Title			
Size	Number		Revision
A			
Date:	1/31/2020		Sheet of
File:	C:\ICEBoard\ICEBoard_working.SchDoc		Drawn By:

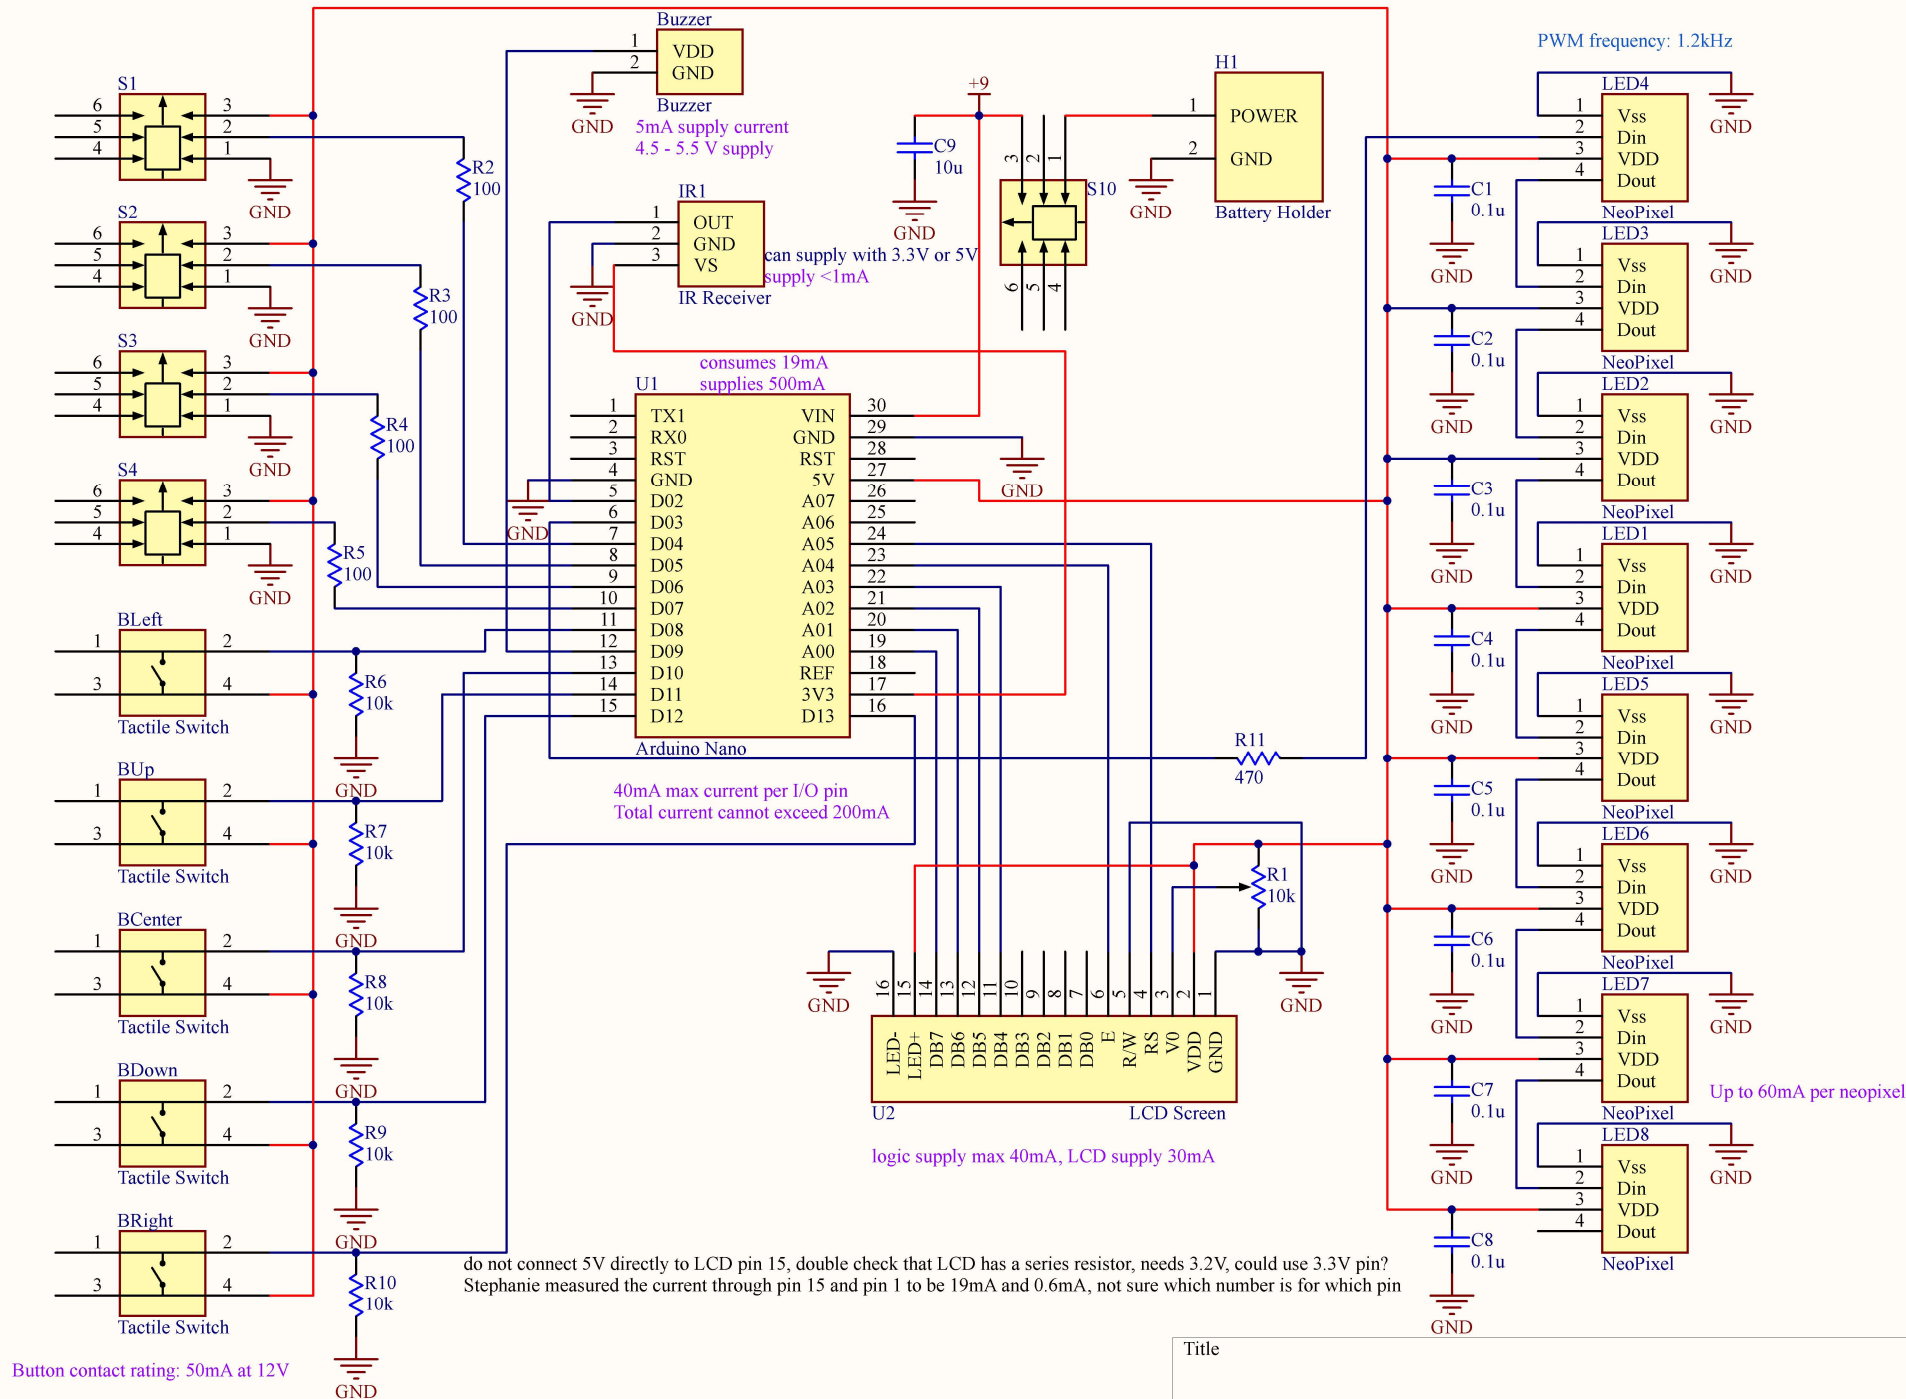
Button contact rating: 50mA at 12V

do not connect 5V directly to LCD pin 15, double check that LCD has a series resistor, needs 3.2V, could use 3.3V pin?  
Stephanie measured the current through pin 15 and pin 1 to be 19mA and 0.6mA, not sure which number is for which pin
